weekly notice

Monday, 14 August 2017
Sunday, 20 August 2017

*GENERAL MANAGER SAFETY AND STANDARDS
SYDNEY TRAINS*

BLACKTOWN
SIGNALLING ARRANGEMENT
HIGH SPEED CROSSOVER INSTALLATION
Produced by AECOM VER05072017

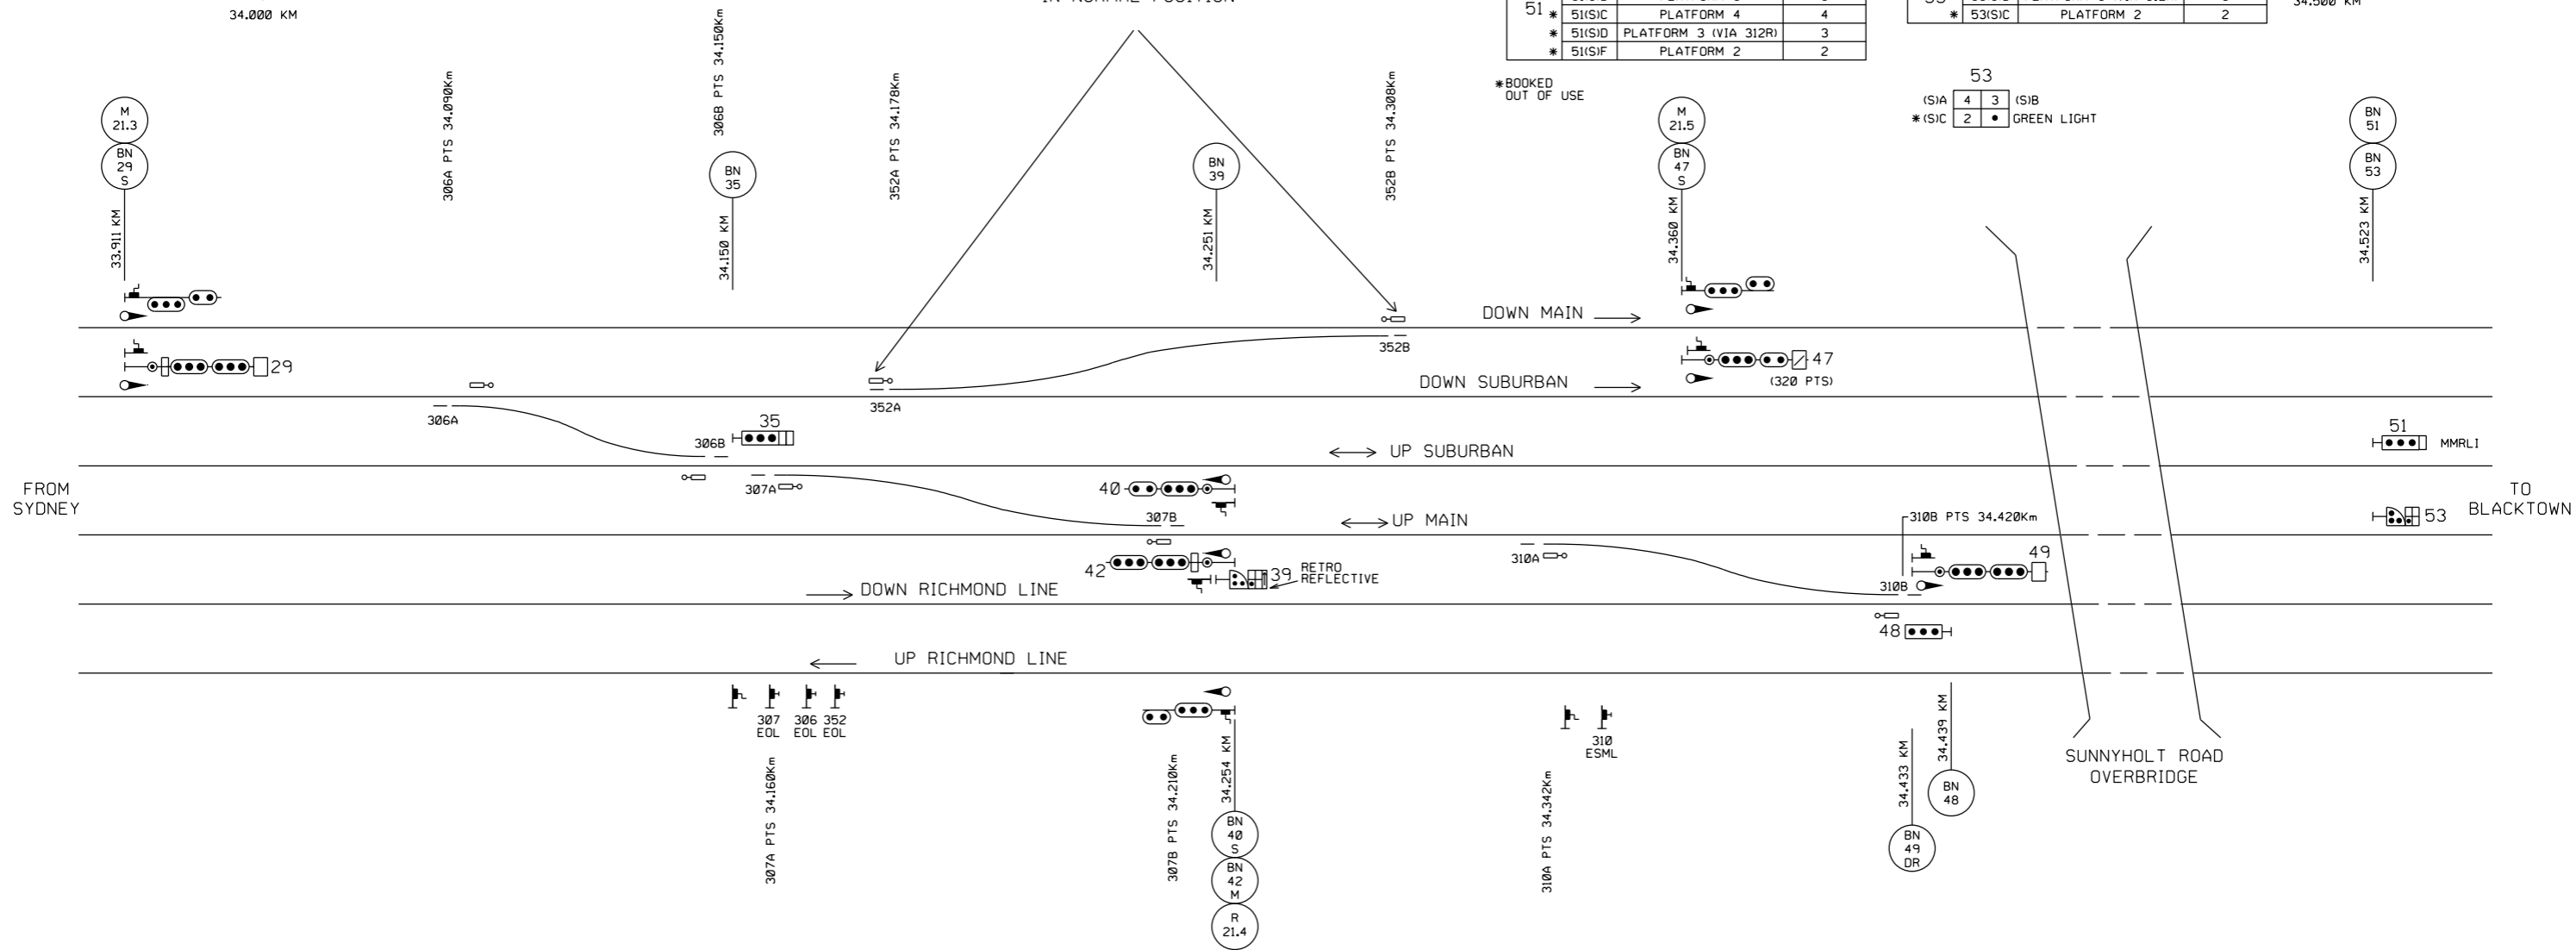
BLACKTOWN - INSTALLATION OF 352A AND 352B POINTS

- 352A points will be installed at 34.178Km on the Down Suburban between Seven Hills and Blacktown.
- 352B points will be installed at 34.308Km on the Down Main between Seven Hills and Blacktown.
- 352A and 352B points will be spiked, clipped, XL locked and detected in the normal position until further notice.
- An Emergency Operation Lock (EOL) will not be provided at this stage.
- No alterations will be made to the controls and indications at Blacktown Signal Box.
